Maule Aircraft Corporation

Service Letter #13
MODELS EFFECTED M-4, M-4C, M-4T, M4S, M-4-210, M-4-210C,
M-4-220C, and M-4-220S
Mandatory on Serial No's 68 thru 94, 1C thru 10C. 1T thru 3T,
1S thru 3S, 1001 thru 1045, 1001C thru 1062C, 2001C thru 2004C
and 2001S.

INSTRUCTIONS
FOR
SERVICE LETTER #13

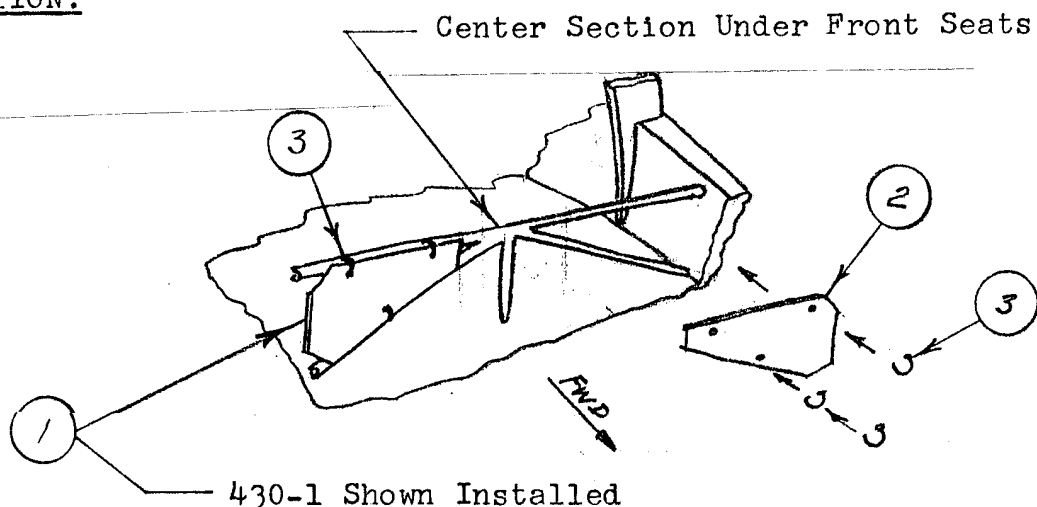
Due to reports of persons unfamiliar with our aircraft confusing the fuel line, which runs across under the front seats, with the seat adjustment handle, there has been one incident in which a passenger pulled on the line by mistake causing a fuel leak in the cockpit. To eliminate this from happening we have designed a plate which when installed on the center section below the seats makes it impossible to get a hold of the fuel line by mistake.

1. Locate Guard Plates 1 and 2 over front of center section tubes as shown (Force to outside for good fit).
 2. Secure in place using 3 Tie Clamps around tubes and thru holes in 1 and 2 plates.
 3. Please fill out enclosed card and return when this installation is made.
- * If the fuel line projects forward of the center section making contact with the Guard Plate when installed, the fuel line will have to be rerouted rearward as shown on page 2 of these instructions.

VIEWED FROM TOP

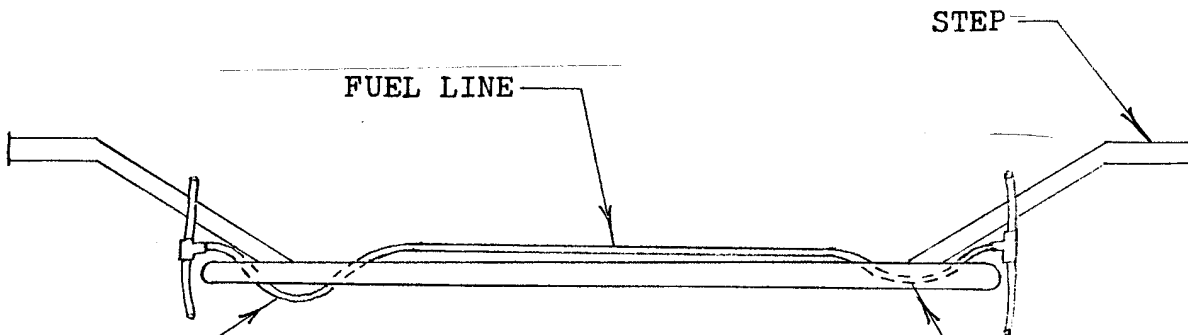
-IF YOUR FUEL LINE PROJECTES FORWARD OF TUBE SECTION AS SHOWN HERE. REROUTE FOR CLEARANCE BETWEEN FUEL LINE AND GUARD PLATE AS SHOWN HERE

VIEW LOOKING AFT

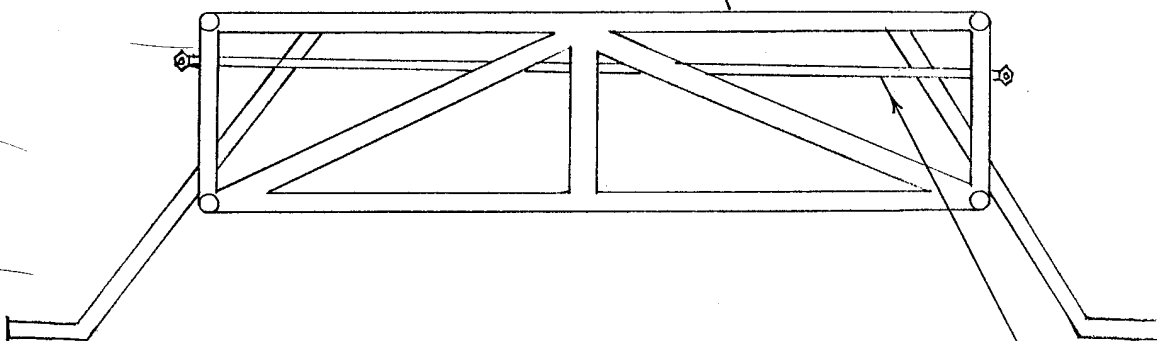
ROUT FUEL LINE KEEPING IT LEVEL WITH NO LOW SPOTS.
